ENGINEERING CHANGE NOTICE

Proj. ECN B-714-115

5. Project Title/No./Work Order No. B-714/ER8007
Grouted Waste Diposal Facilities

6. Bldg./Sys./Fac. No.
218-E-16

Ref. Dwg.	Sh.	Rev.	Prepared By	Checked By	ECN No.	Page
* H-2-77636	2	2	TE COYNE	L.D. JOHNSON	B-714-115	6/19
H-2-77636	4	2				
H-2-78502	2	2				
H-2-78502	4	2

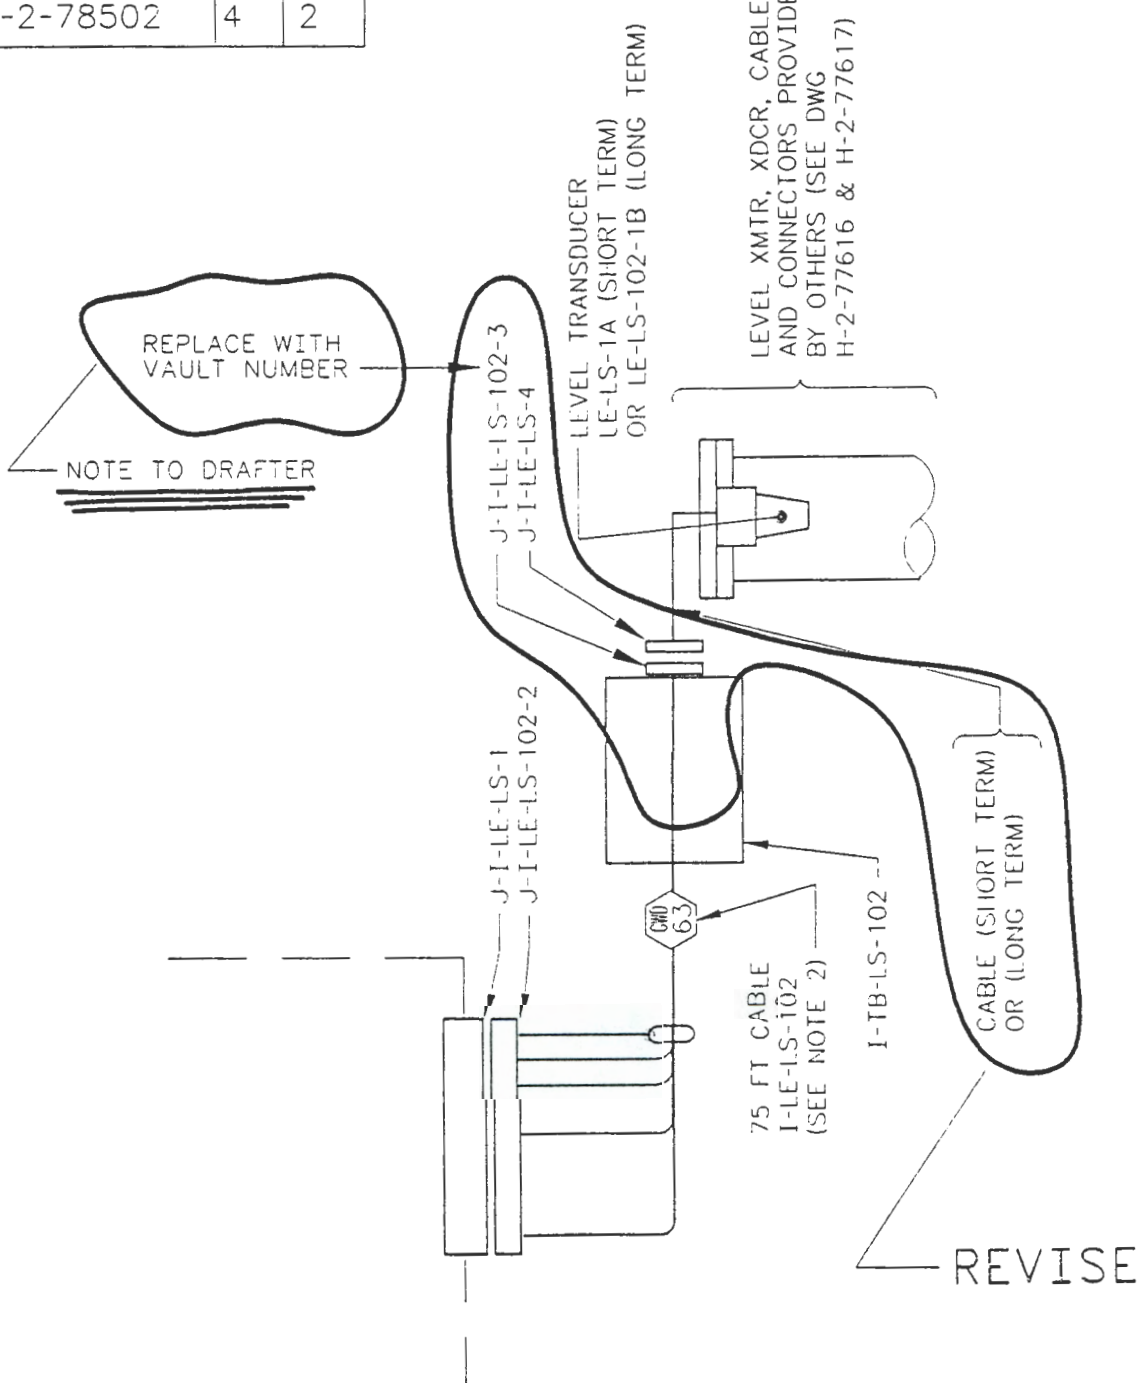
(sc-2) Leachate Level Syst Conn Diag (Z B3): Modify - see page 6 of this ECN.

(sc-2) Leachate Level Syst Conn Diag (Z B6): Modify - see page 6 of this ECN.

(sc-2) Leachate Level Syst Conn Diag (Z A6): Modify - see page 6 of this ECN.

(sc-2) Leachate Level Syst Conn Diag (Z A6): Modify - see page 6 of this ECN.

Ref. Dwg. H-2-77638	Sn. 1	Rev. 1	Prepared By TE COYNE	Checked By 2/27/92 P.K. Marlowe	ECN No. E-714-115	Page 7/19
------------------------	----------	-----------	-------------------------	---------------------------------------	----------------------	--------------

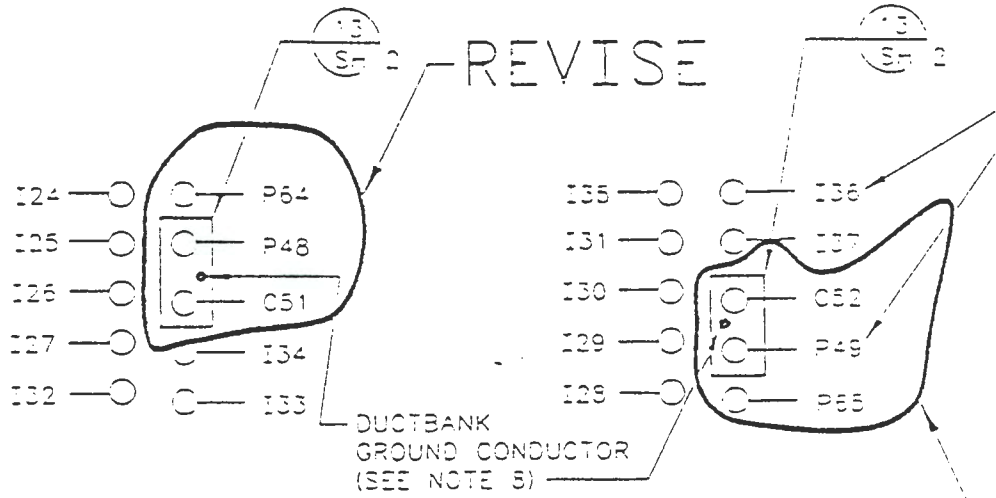
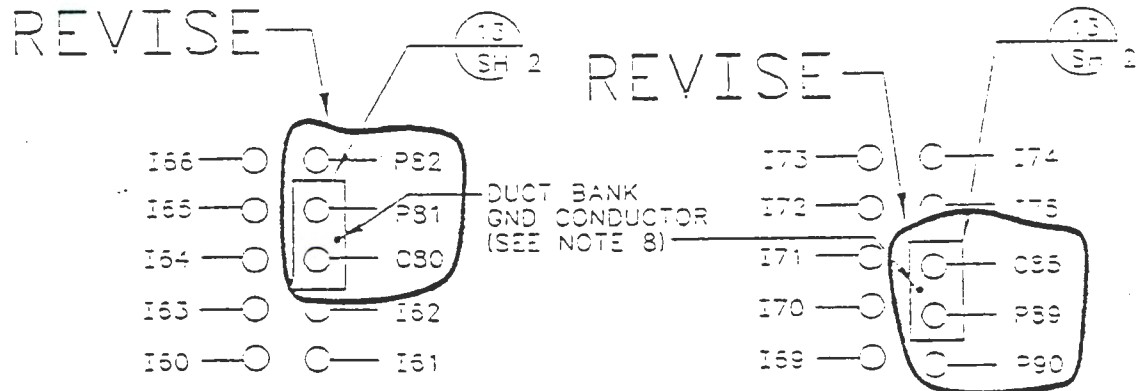
(sc-2) A) Detail 9 (Z D4) & Detail 10 (Z D3): Modify - see page 7 of this ECN.

(sc-2) A) Stub-up Detail, Typical 2 places (Z D3-4): Modify - see page 7 of this ECN.

Ref. Dwg.
H-2-77638

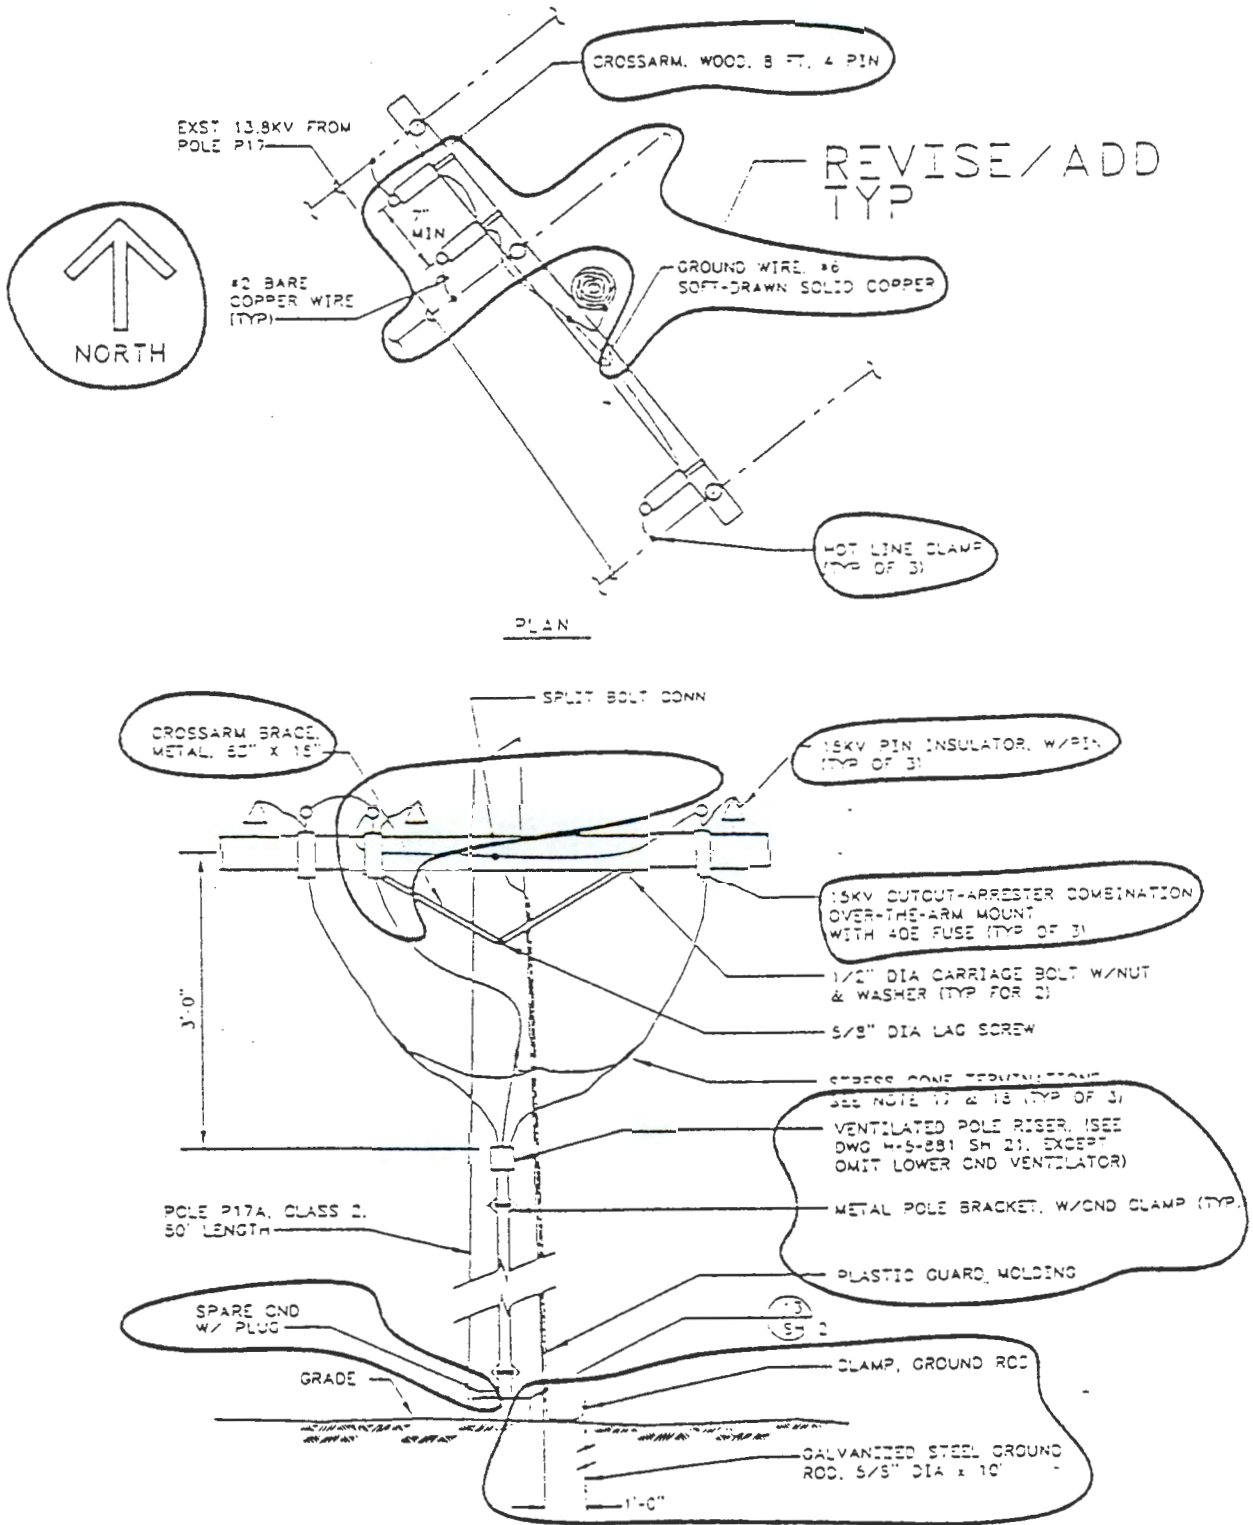
A) Elevation 4 (Z A7-D8): Modify - see page 8 of this ECN.

1) Delete all manufacturer's catalog numbers.

2) Relocate "B" phase conductor and cutout/arrester to opposite side of pole.

3) Show the location of spare conduit.

4) Replace #6 iron wire (note 18) with #6 copper wire.

5) Replace (2) ground rods with (1) 10' ground rod.

Ref. Dwg. H-2-77638	Sh. 3	Rev. 1	Prepared By TE COYNE	Checked By 4-2-92 R.K. [Signature]	ECN NO. 3-714-115	Page 9/19
------------------------	----------	-----------	-------------------------	--	----------------------	--------------

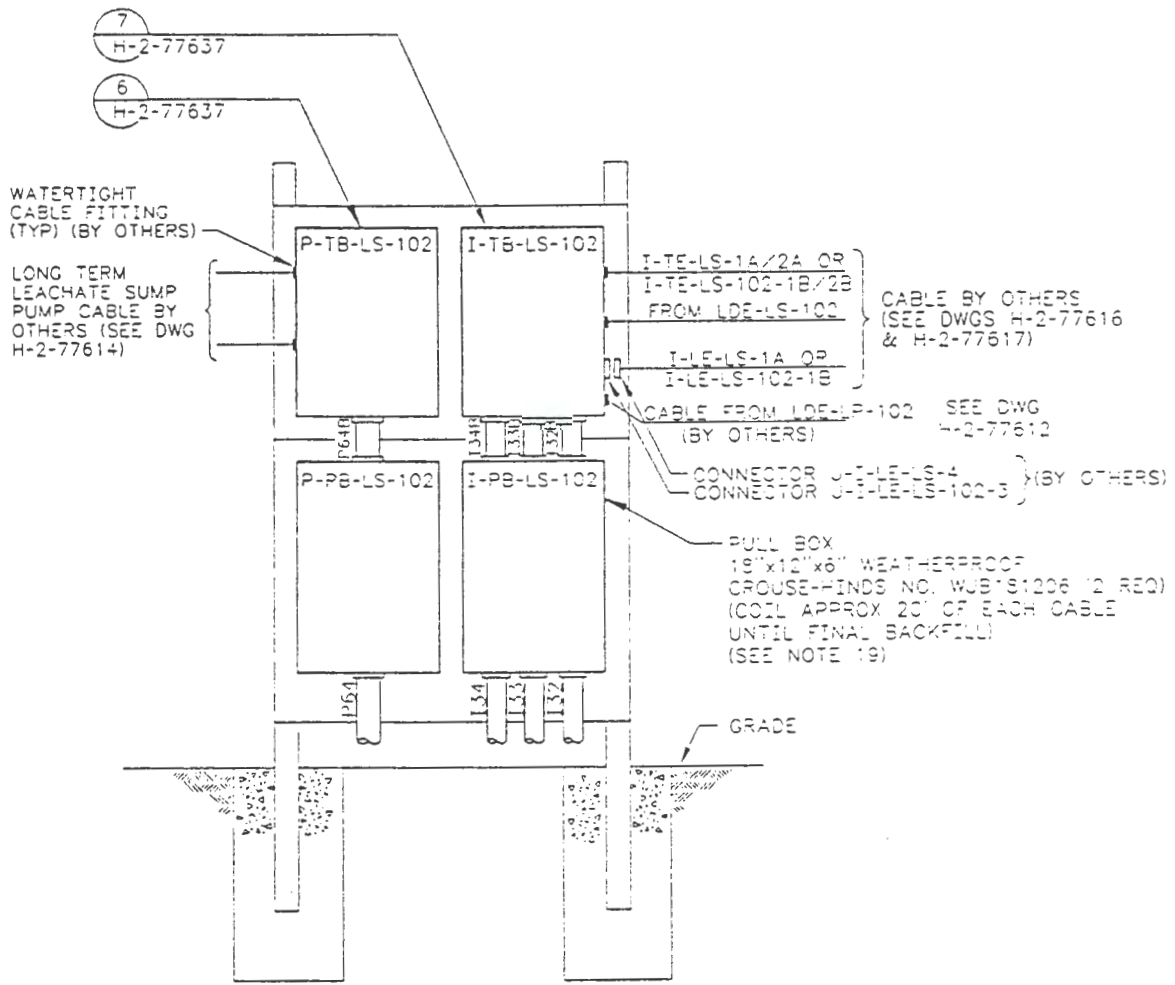
(sc-2) B) Detail 5 (Z D1 - F2): Replace with new detail 5 as shown on page 9 of this ECN. (Incorporates ECN B-714-95, page 7, item 25)

VAULT 102 LEACHATE PIT RACK THIS DWG & H-2-77635 SH 1
(SEE DWG H-2-77594 FOR STRUCTURAL FRAMING DETAILS AND MATERIALS REQUIRED FOR FASTENING EQUIPMENT)

Ref. Dwg. H-2-77638	Sh. 3	Rev. 1	Prepared By TE COYNE	Checked By 4-2-92 <i>R.K. Newhouse</i>	ECN No. B-714-115	Page 10/19
------------------------	----------	-----------	-------------------------	--	----------------------	---------------

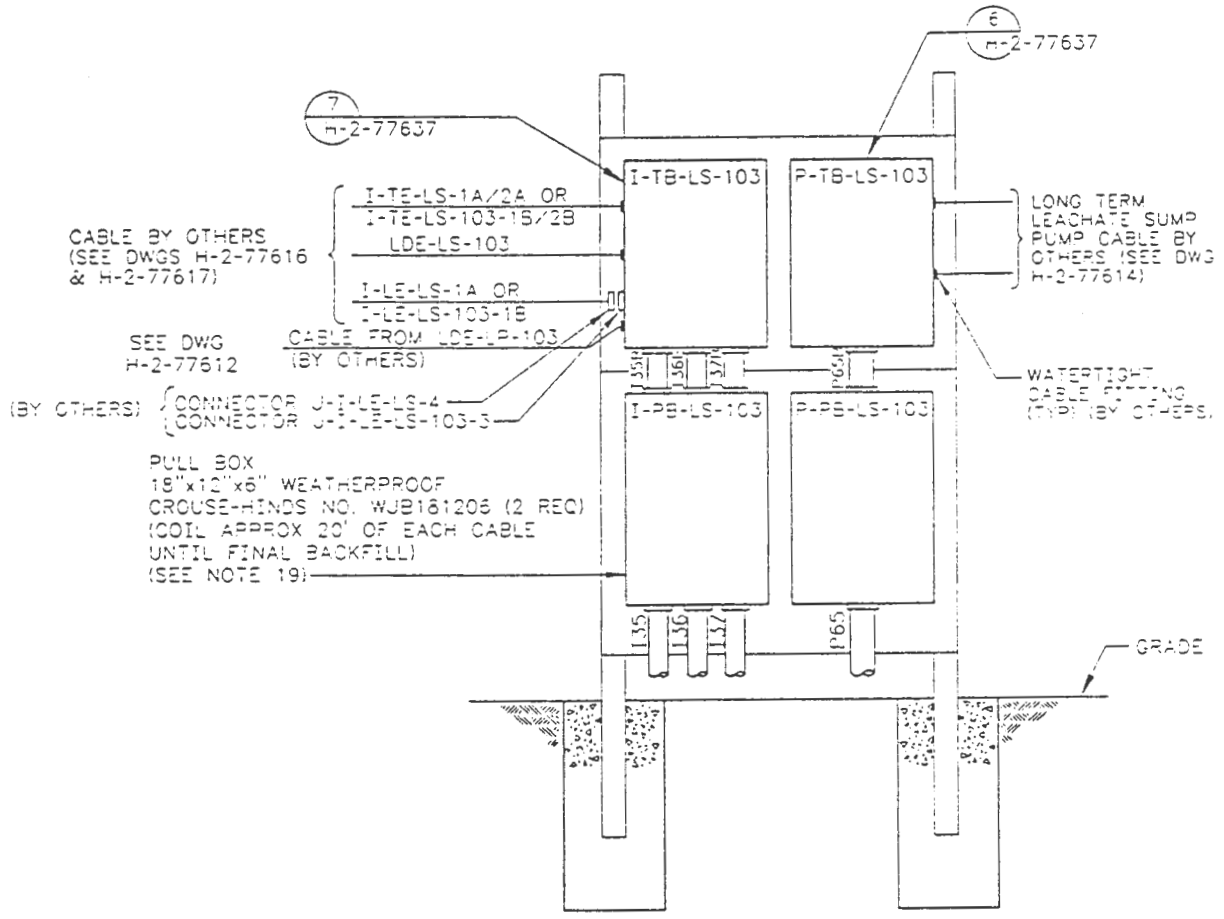
(sc-2) C) Detail 14 (Z D3-F4): Replace with new detail 14 as shown on page 10 of this ECN. (Incorporates ECN B-714-95, page 7, item 25)

Vault 103 Leachate Pit Rack 14 THIS DWG & H-2-77635 SH 2
(SEE DWG H-2-77594 FOR STRUCTURAL FRAMING DETAILS AND MATERIALS REQUIRED FOR FASTENING EQUIPMENT)

Ref. Dwg. H-2-77639	Sh. 1	Rev. 2	Prepared By TE COYNE	Checked By 4-2-92 <i>R.K. Newhouse</i>	ECN No. B-714-115	Page 11/19
H-2-77639	2	2				
H-2-78505	1	2				
H-2-78505	2	2

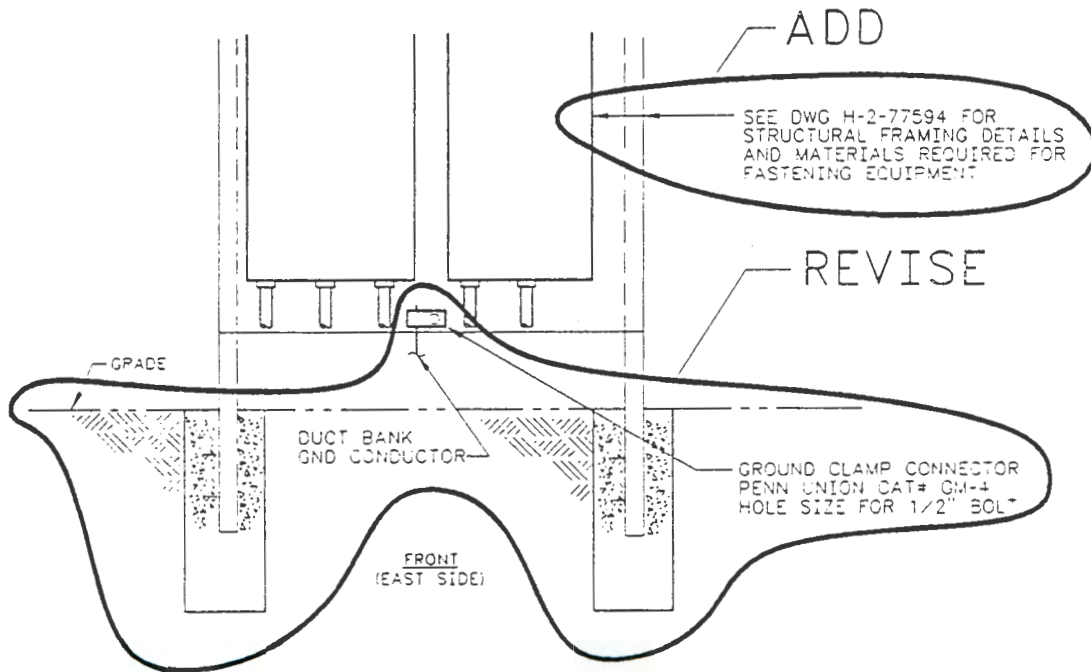
(sc-2) A) Elevation J, Front View (Z C6-E7): Modify - see page 11 of this ECN.

(sc-2) A) Elevation K, Front View (Z C6-E7): Modify - see page 11 of this ECN.

- (sc-2) A) Elevation, Front (Z D6-E7): Modify - see page 11 of this ECN.
- (sc-2) B) Elevation, Rear (Z C3-E5): Replace with new view as shown on page 18 of this ECN.

- (sc-2) A) Elevation, Front (Z C6-E7); Modify - see page 11 of this ECN.
- (sc-2) B) Elevation, Rear (Z C2-E4): Replace with new view as shown on page 19 of this ECN.

Ref. Dwg.
H-2-77639

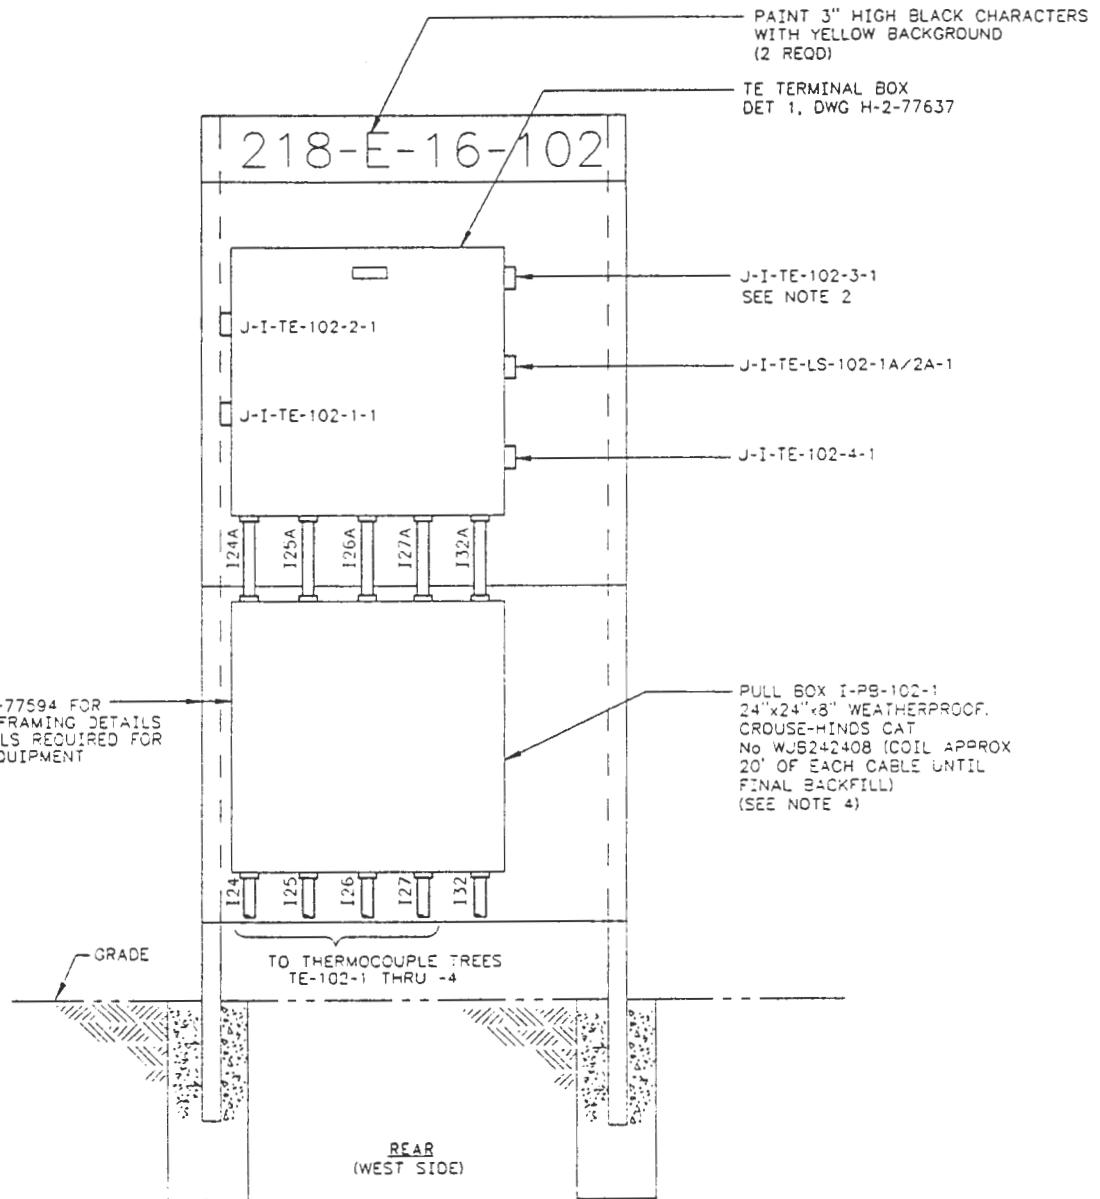
(sc-2) B) Elevation J, Rear View (Z C3-E4): Replace with new view as shown on page 12 of this ECN.

Ref. Dwg. H-2-77639	Sh. 2	Rev. 2	Prepared By TE COYNE	Checked By 4-2-92 R. K. [Signature]	ECN No. B-714-115	Page 13/19
------------------------	----------	-----------	-------------------------	---	----------------------	---------------

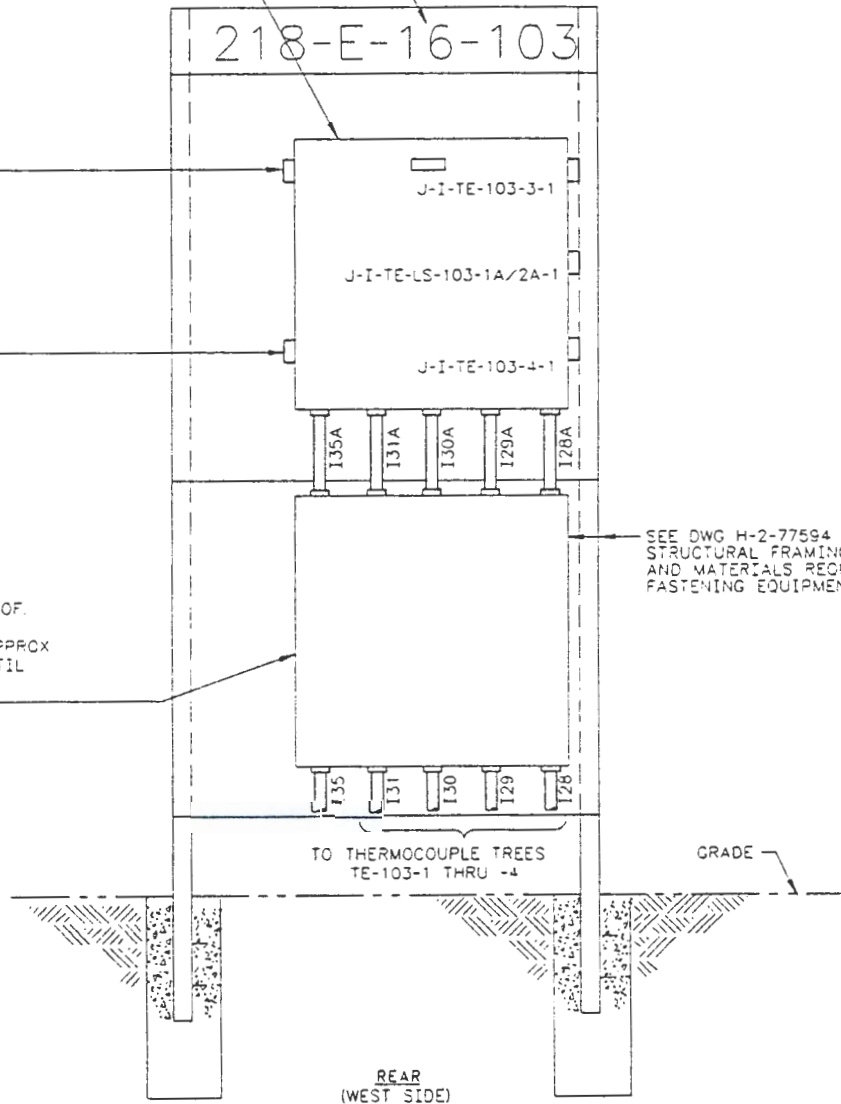
(sc-2) B) Elevation K, Rear View (Z C2-E4): Replace with new view as shown on page 13 of this ECN.

SEE DWG H-2-77594 FOR
STRUCTURAL FRAMING DETAILS
AND MATERIALS REQUIRED FOR
FASTENING EQUIPMENT
